STAFF REPORT: FEBRUARY 7, 2024 MEETING

APPLICATION NUMBER: HDC2024-00004

ADDRESS: 15123 ARTESIAN

SCOPE: REPLACE ORIGINAL WINDOWS WITH COMPOSITE WINDOWS

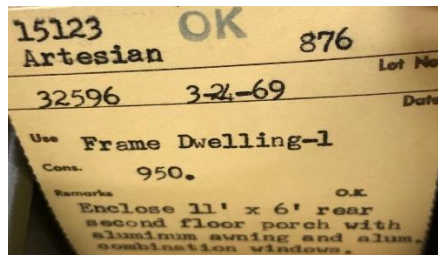
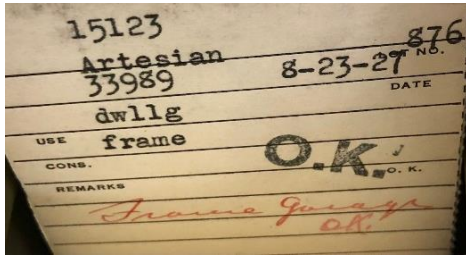
All four exterior walls are covered with vinyl siding, obscuring the original architectural character of the house. The raised front porch, concrete stairs, aluminum handrail and metal storm door were in place at time of

designation, as was the second-floor rear porch enclosure.

Front North-side Rear South-side

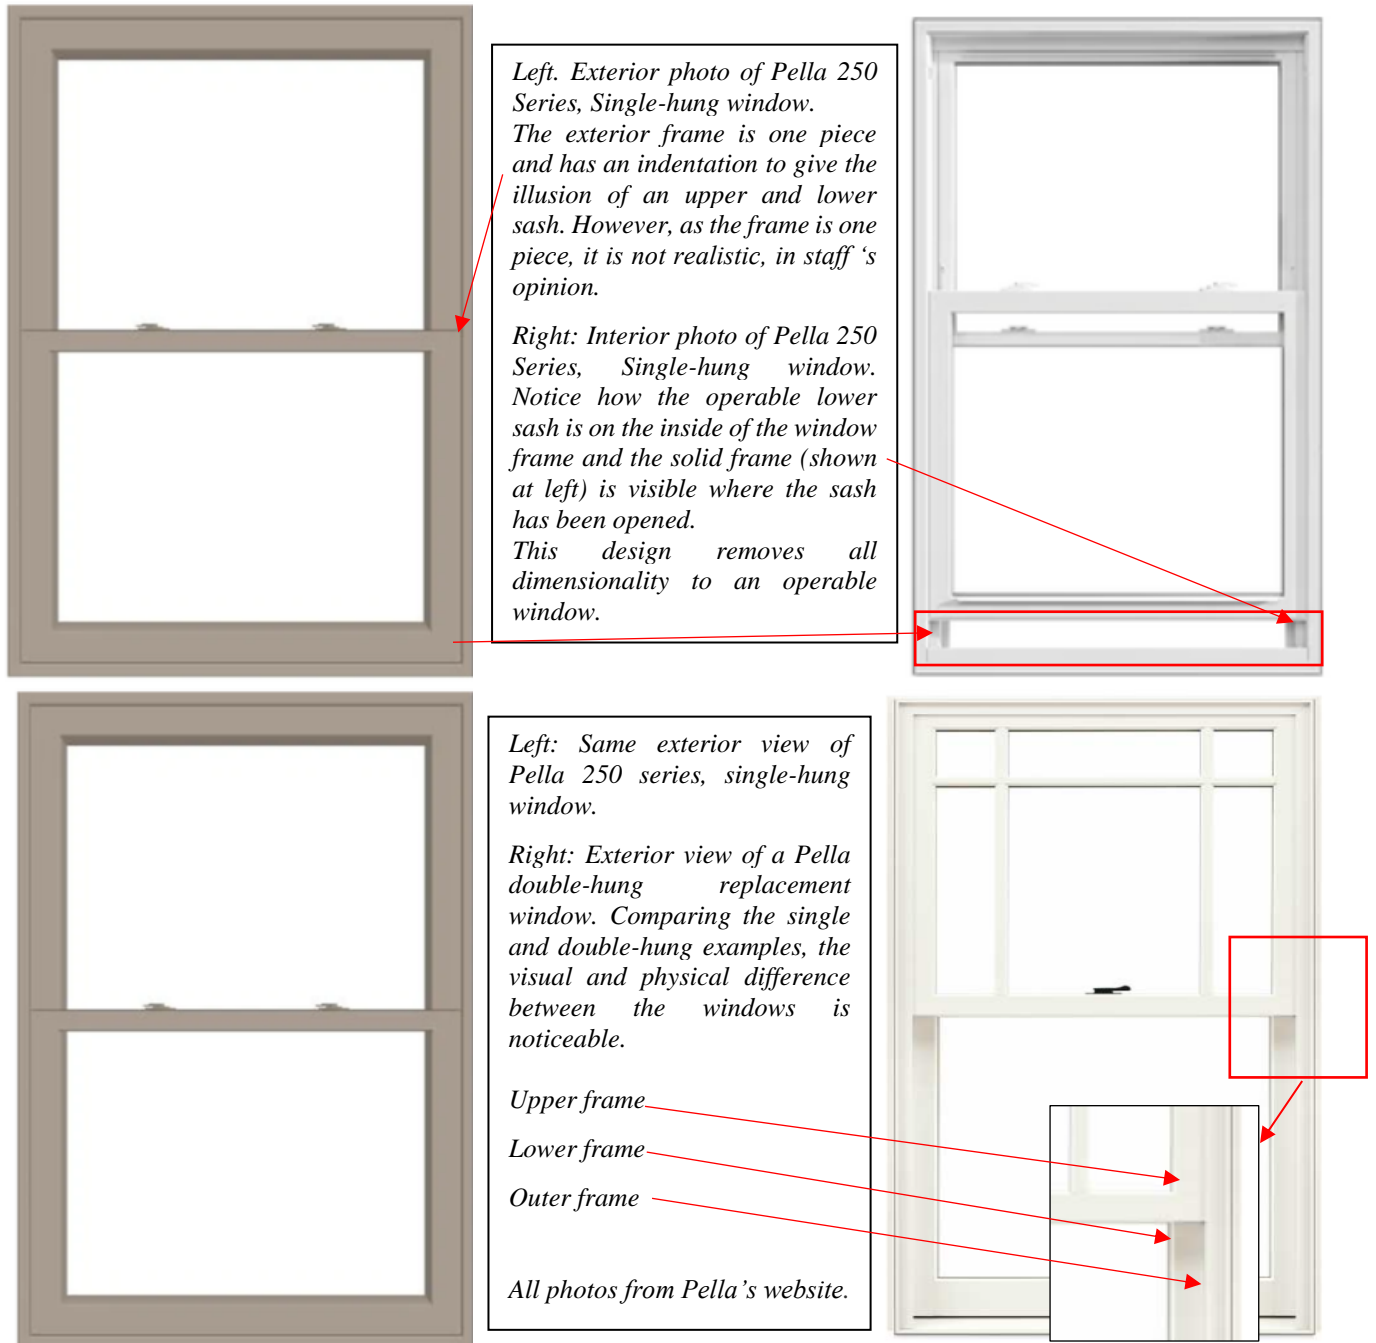
- Vinyl window to remain
- Wood windows (11) to be restored, aluminum storm windows fabricated
- Wood windows (6) to be restored, wood storms to be restored

- The existing wood windows are distinctive character-defining features of this house. The materiality, multiple operations, grouped openings, dimensionality and divided light window patterns help to identify the era and Tudor Revival architectural style of the house. Their loss would destroy any remaining historic character at this property, already substantially lost due to the incompatible and ahistorical vinyl siding.
